## HYDROLOGIC DATA REVIEW

**King County Solid Waste Division**

**Harper Owes**

7/20/88

# What is the Groundwater Flow Direction in the Deep Aquifer?

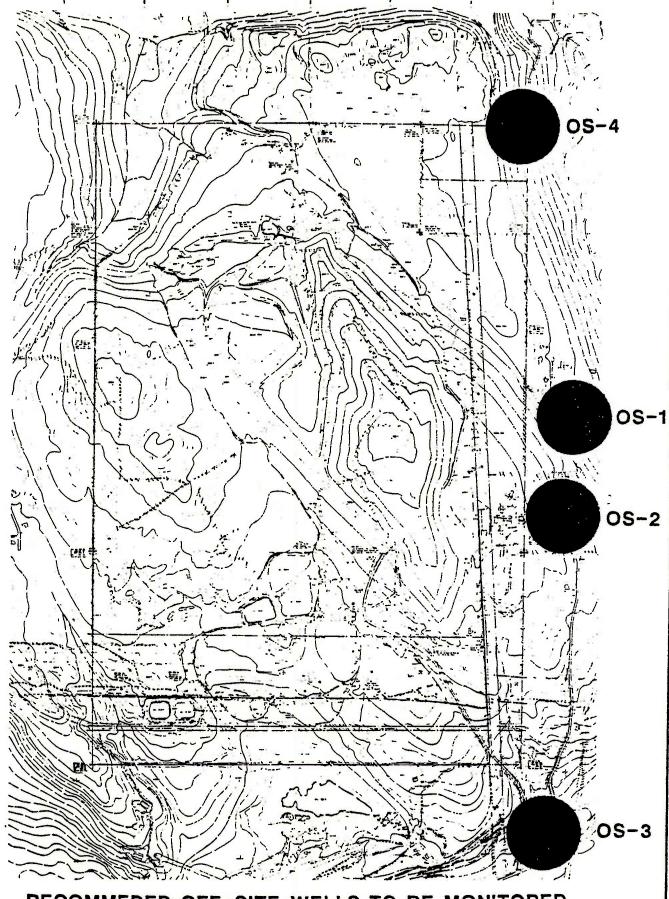
- North EAST or North WEST?
- · Has the flow direction been refined further?
- How does flow change as production wells are pumped?
- · Offsite wells being monitored are to the NE, E, SE.
- Could Wells # 18 and # 22 (Parametrix, 1986) be sampled?

#### **Leachate Head Reduction Study**

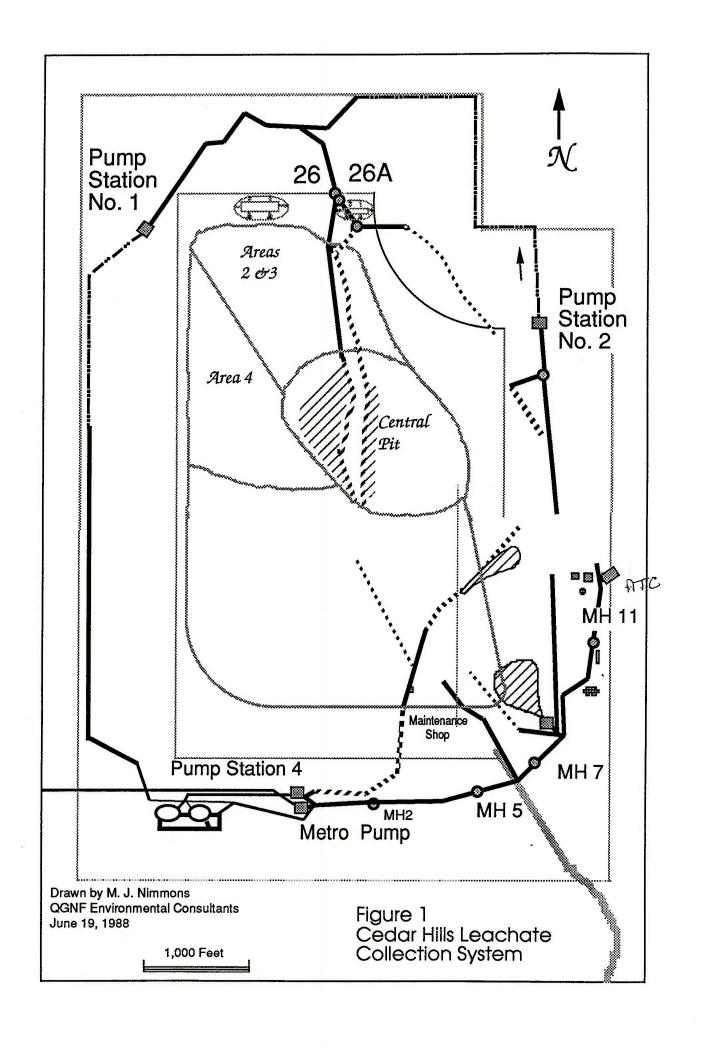
**Analysis of the Conclusions:**

**Three Design Options**

- 7 horizontal drains
- 25 vertical wells
- · Combination of wells and drains

Sweet-Edwards considered the effectiveness, cost, and feasibility of all options. Conclusions are reasonable based on assumptions and limitations of the data. However, more data are needed to evaluate and design the system.

#### **Data Limitations**

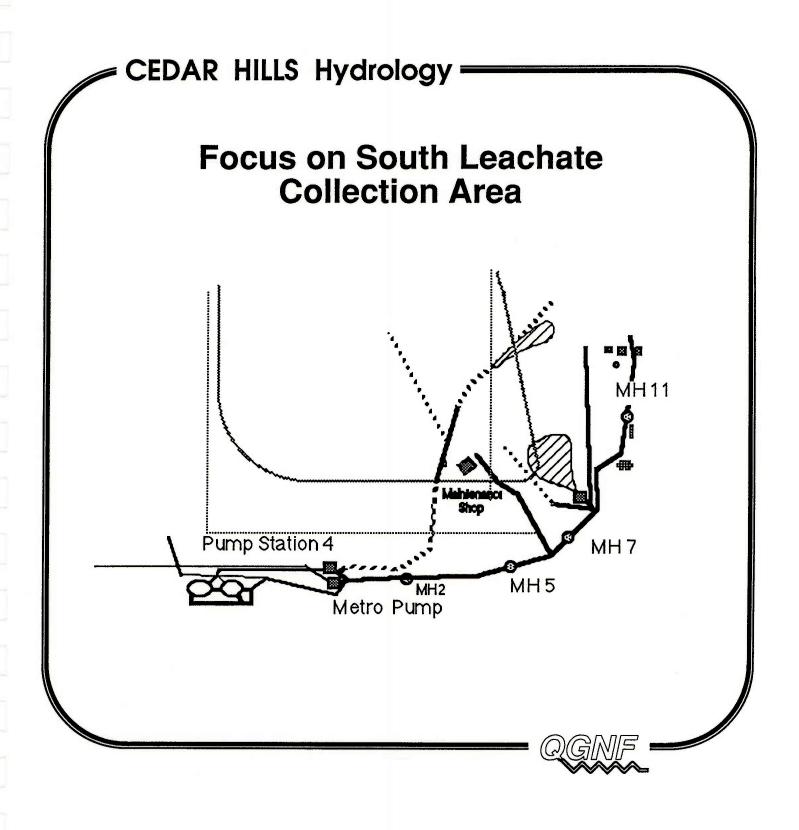
- Though data collected, precipitation reports not available after March 30, 1988.
- Flow Recorder Data for Manholes available from Dec. 16, 1987 thru March 24, 1988.
- Man Hole 2 has NO weir, therefore flow monitoring data not valid.

# Examine Factors Which Could Contribute to Variation

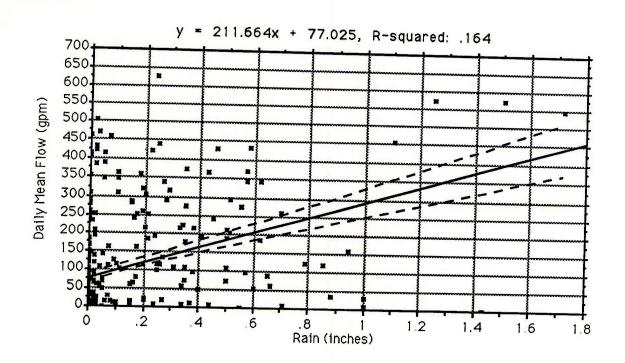
knew all this 4 mos ago.

- Different Bubbler Tube after February 3, 1988.
- Bubbler Tube Fouling Readings immediately before cleaning may be different from readings after cleaning.
- Flows from Maintenance Facility and Alcohol Rehabilitation Center.
- Monitoring record may be <u>statistically</u> inadequate.
